**ADDENDUM NO. 2**

**IMPROVEMENTS TO BAYVIEW PARK, HIGHLAND AVENUE SIDEWALK  
IMPROVEMENTS, AND IMPROVEMENTS TO THE LILLIAN GREGERMAN BANDSHELL  
WAREHAM, MA**

**Bid #1048**

January 30, 2024

**SK-1**

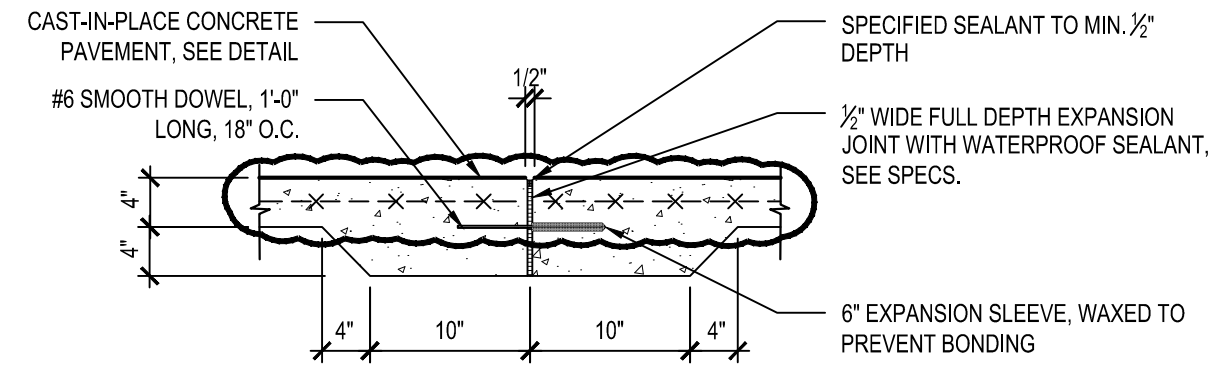
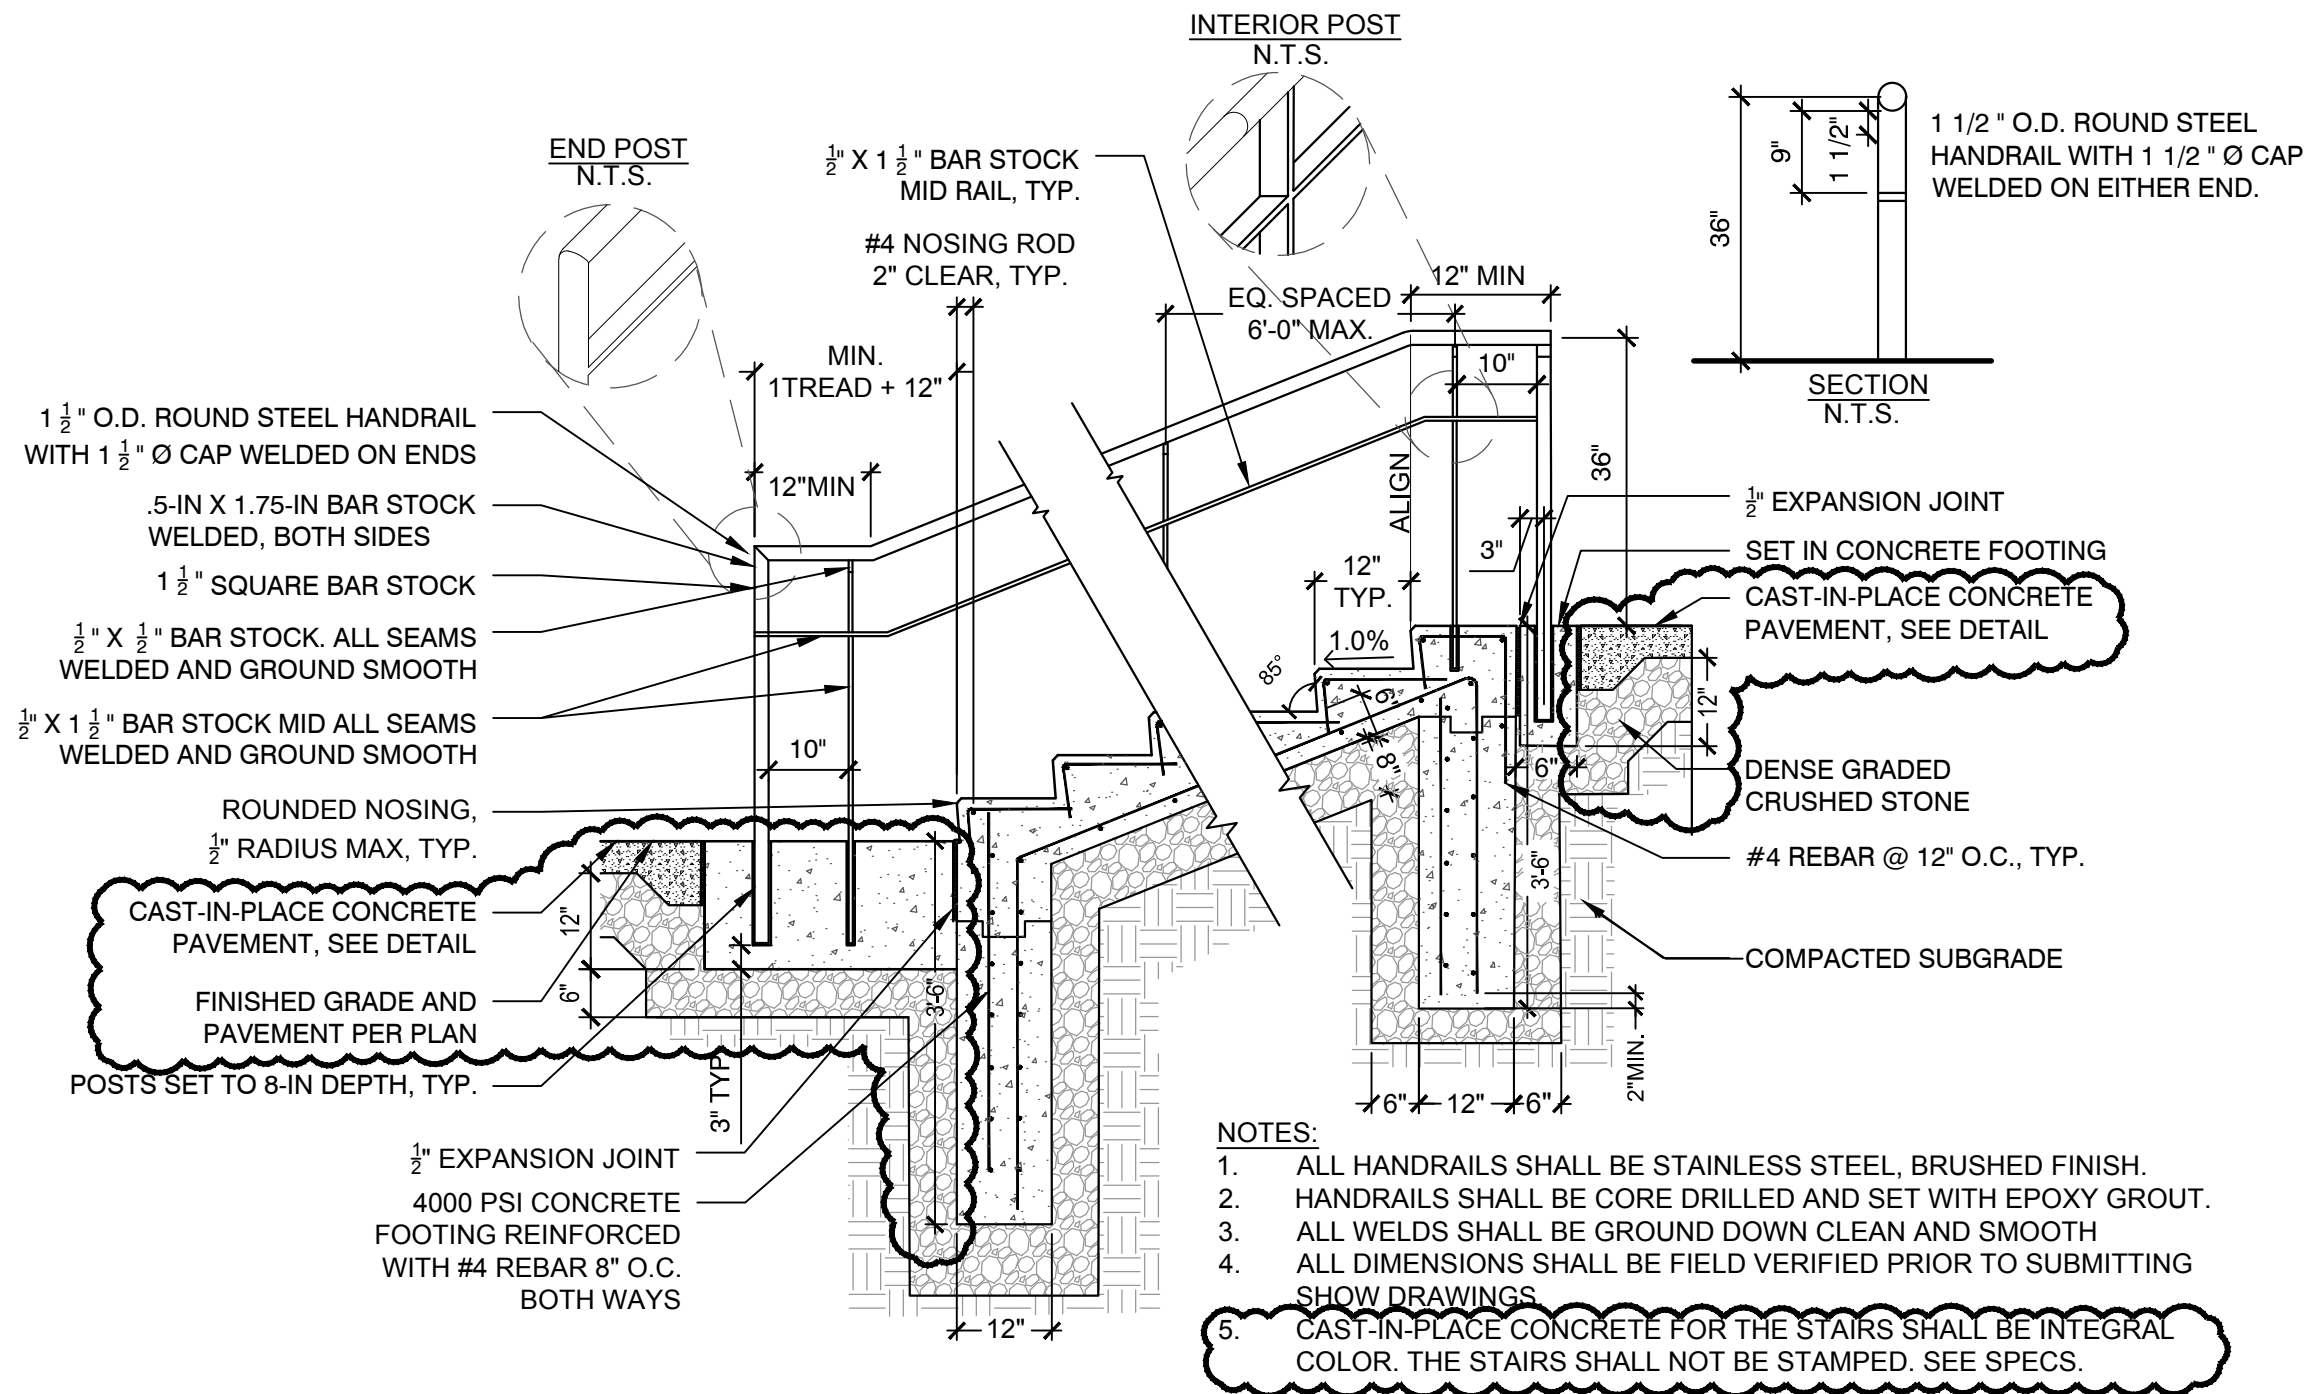
1. **DELETE:** Detail 4, Sheet L503  
**REPLACE:** Detail 4, Sheet L503 in SK-1 per attachment
2. **DELETE:** Detail 1, Sheet L504  
**REPLACE:** Detail 1, Sheet L504 in SK-2 per attachment
3. **DELETE:** Detail 3, Sheet L131  
**REPLACE:** Detail 3, Sheet L131 in SK-3 per attachment

- Answer:** **Replace references in Detail 3, Sheet E501 to civil drawings with Detail 8, L505.**
- Question 5:** Please confirm if any type of reinforcement is required in concrete cast-in-place sidewalks.

- Answer:** **Yes, 4x4 welded wire mesh on chairs is required. See SK-1 included within this addendum.**
- Question 6:** Please confirm if a curing agent is required on broom finished concrete cast-in-place sidewalks.

**SK-2**

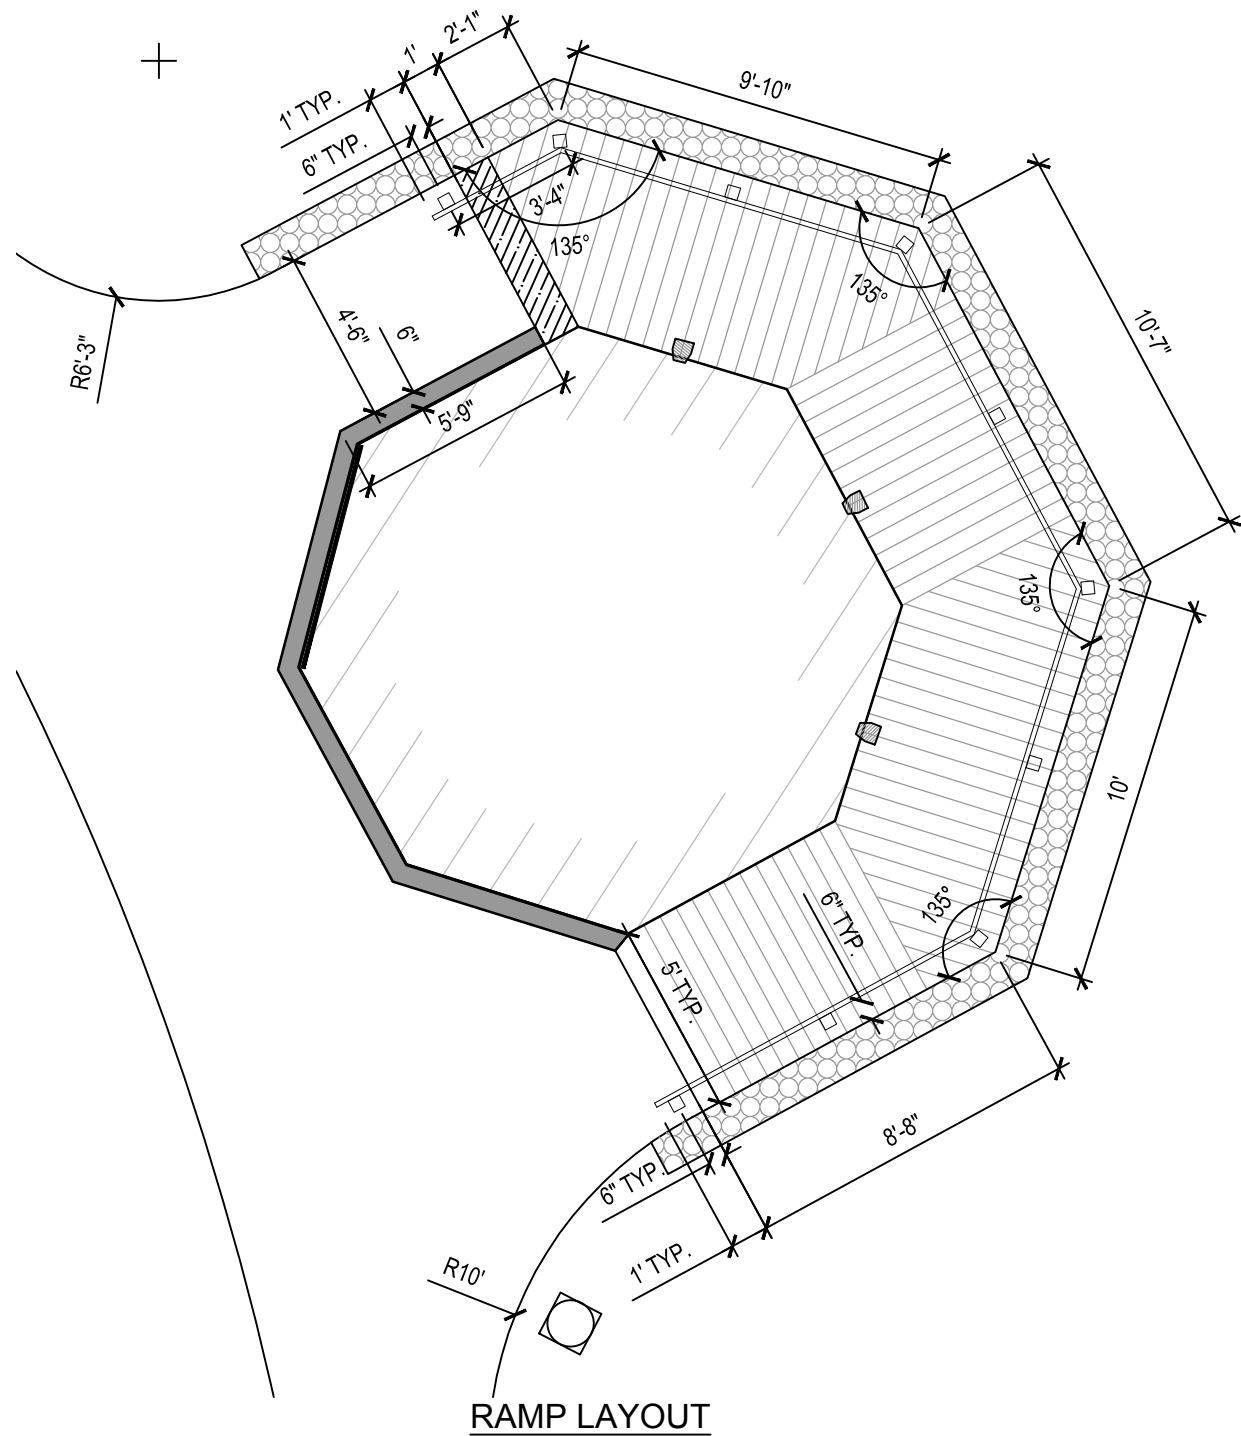
**Question 7:** Please confirm if a footing / frost wall is required for cast in place stairs?

**Question 8:** Are the CIP stairs stamped with integral colors? are the landings stamped?

**Question 9:** Detail 1 L504 denotes stabilized stone dust @ landings, please confirm landings are stamped concrete not stabilized stone dust?

**Answer:** A footing is required as detailed in Detail 1, Sheet L504. Depth of the footing as shown is 3'-6" from top of tread, for both the top and bottom of tread. See SK-2 included within this addendum for further clarification.

**Answer:** The stairs shall be poured with cast-in-place concrete with an integral color. No stamping on the stair treads and landings integral to the stair are required. See SK-2 included within this addendum.

**Answer:** The stairs meet integral colored stamped cast-in-place concrete pavement. See SK-2 included within this addendum.

**SK-3**

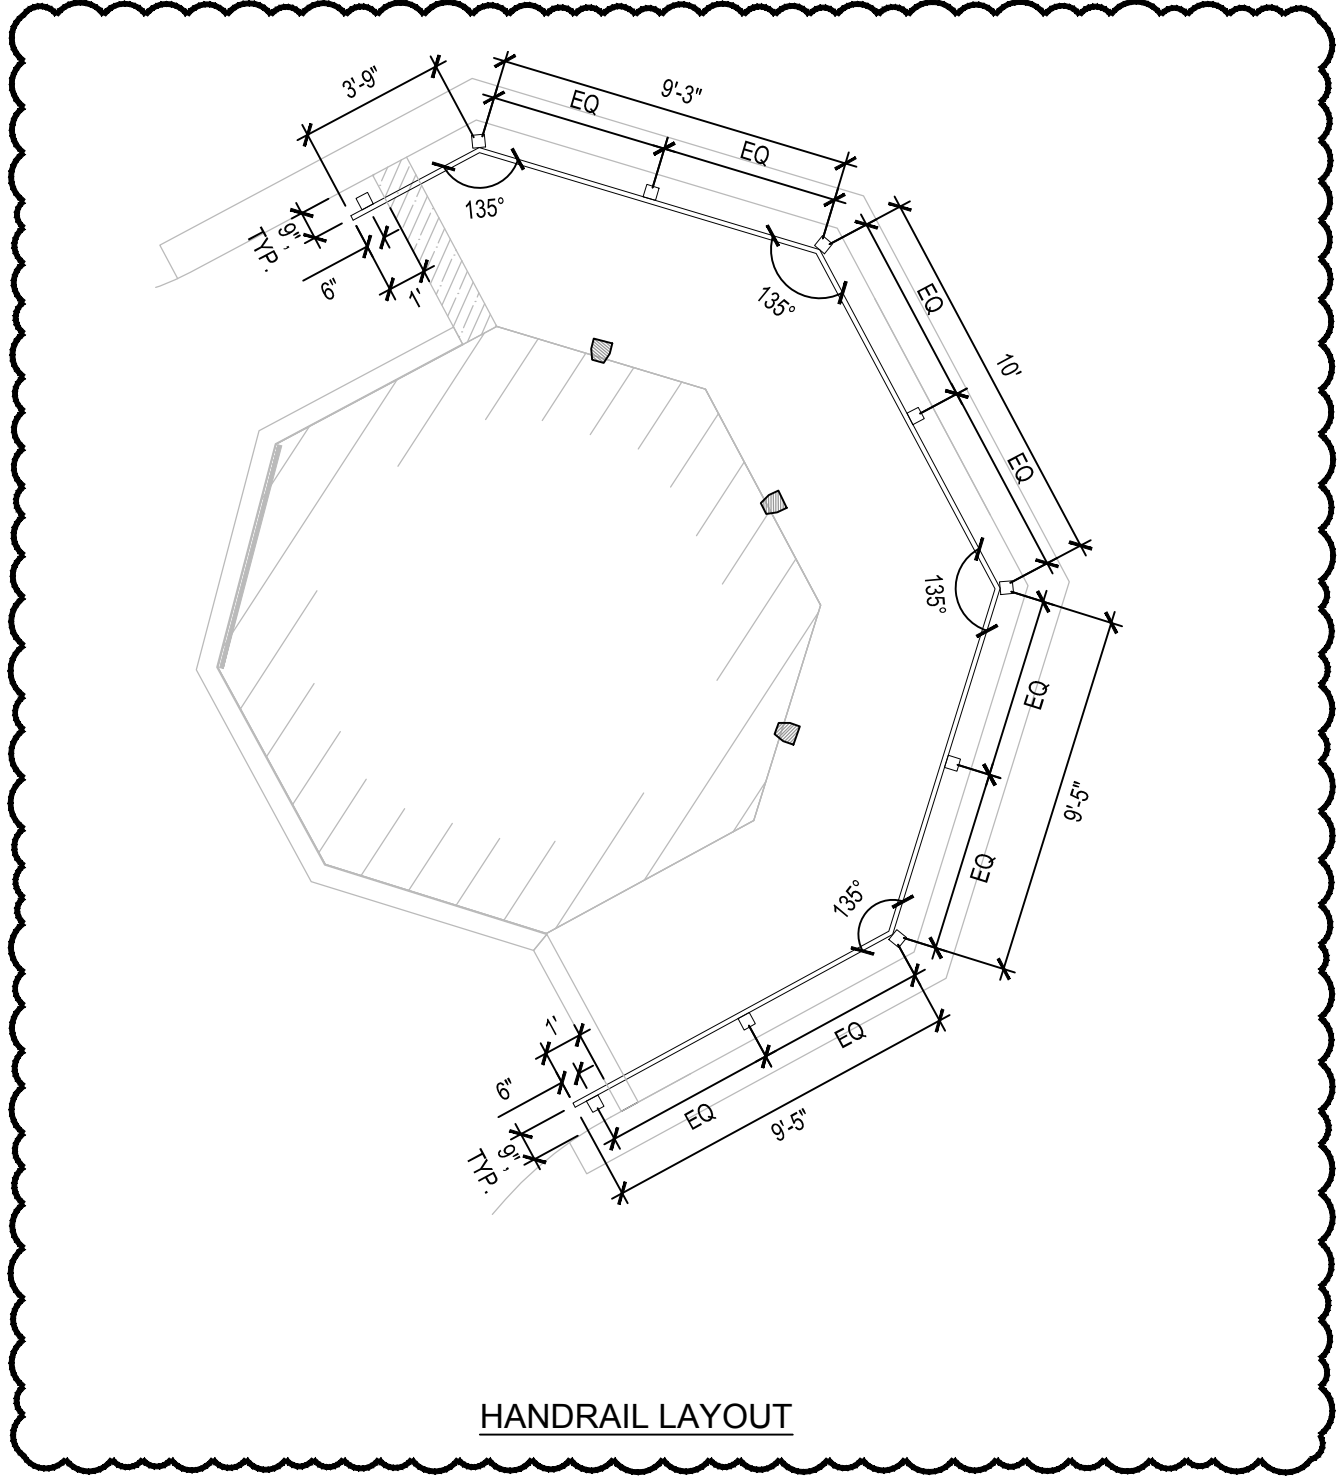
**Question 10:** Please confirm the extent of the handrail along the ramp side of the gazebo.

**Answer:** See SK-3 for layout clarification.
